ASSESSMENT REPORT

WAMBO COAL MINE Montrose East Dam Modification (305-7-2003 MOD 11)

Figure 3 - Proposed layout of Montrose East Dam

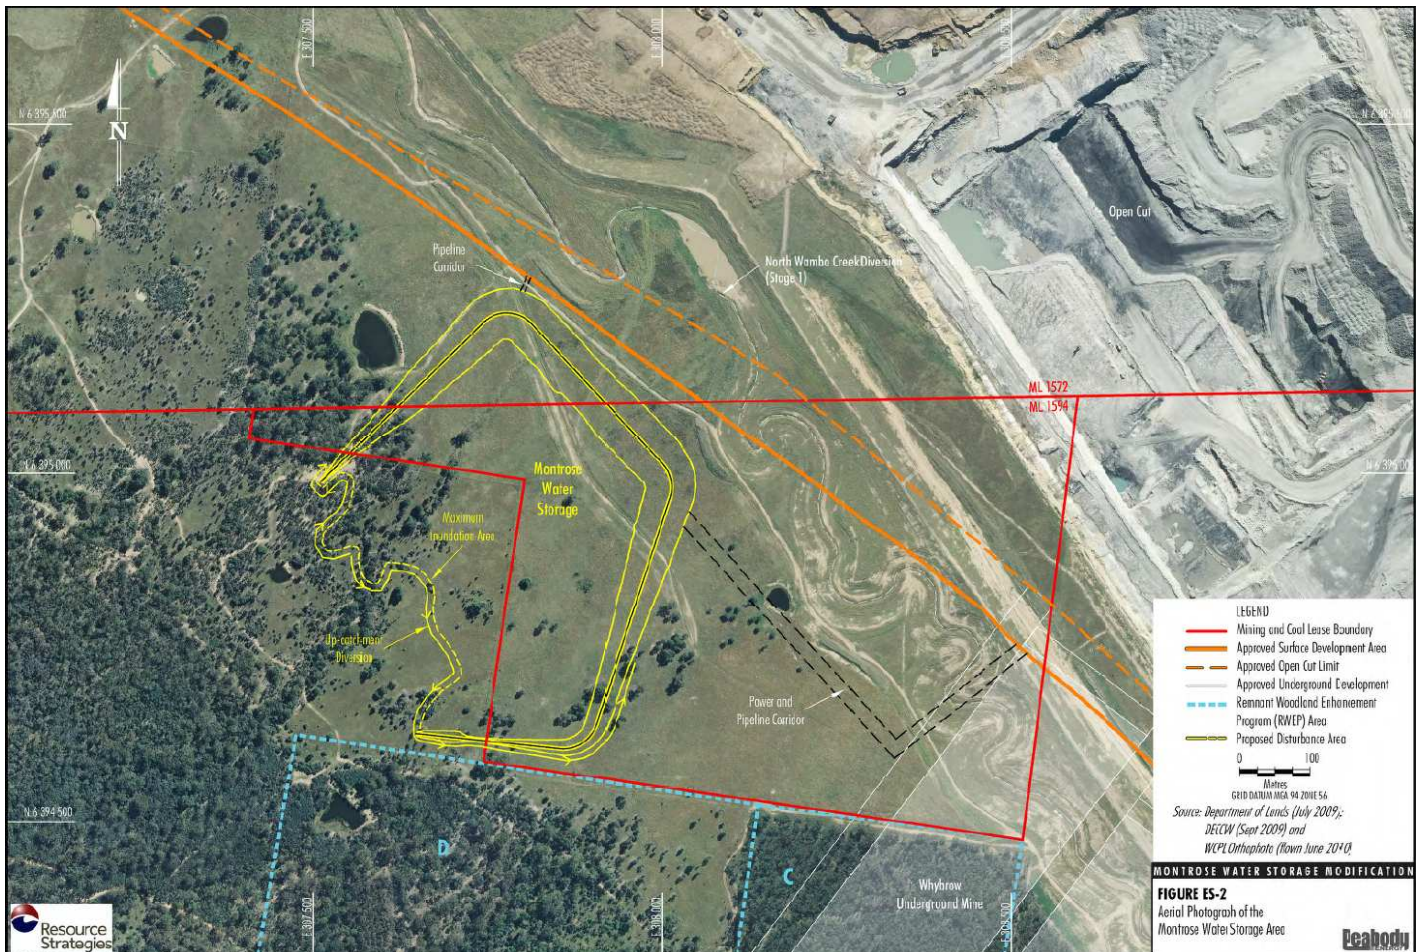
While land clearing and removal of hollow-bearing trees and deadwood are listed key threatening processes, the young regrowth vegetation in the area to be cleared is unlikely to have any such significant roosting sites. The Department considers that the proposed clearing of woodland is minor in extent (2.6 ha) and is unlikely to sever or fragment other good quality habitat. As can be seen in the aerial photograph in **Figure 3**, there are no contiguous woodland areas to the north, east or south of the dam site.

Figure 4 - Locations for proposed biodiversity offsets

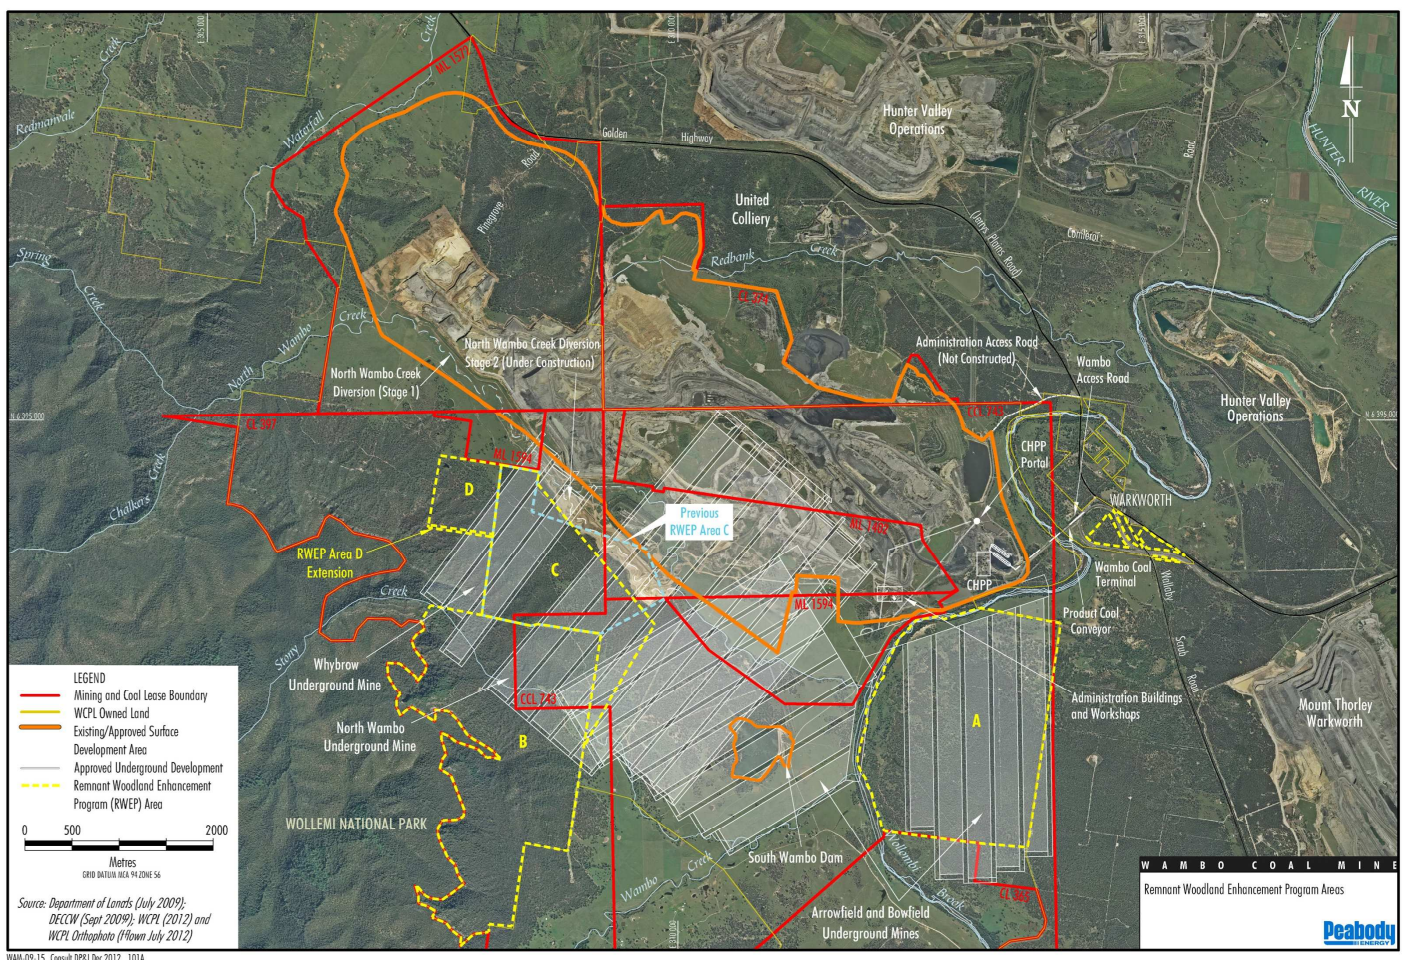
The revised offset area is summarised in **Table 1** below and shown in **Figure 4** (see the area marked D).

The proposed offset area includes 'like-for-like' vegetation communities compared to those communities that would be cleared. That is, the Box-Ironbark Woodland to be cleared would be offset by Box-Ironbark Woodland, and the Slaty Box Woodland would be offset with Slaty Box Woodland. Further, the Department is satisfied that the vegetation in the proposed offset area is of considerably better quality than the vegetation in the proposed disturbance area, as it has a superior structure with a full canopy at natural densities, and has been subjected to very little disturbance. Finally, the proposed offset area is contiguous with Wambo's other established offset areas and the Wollemi National Park.
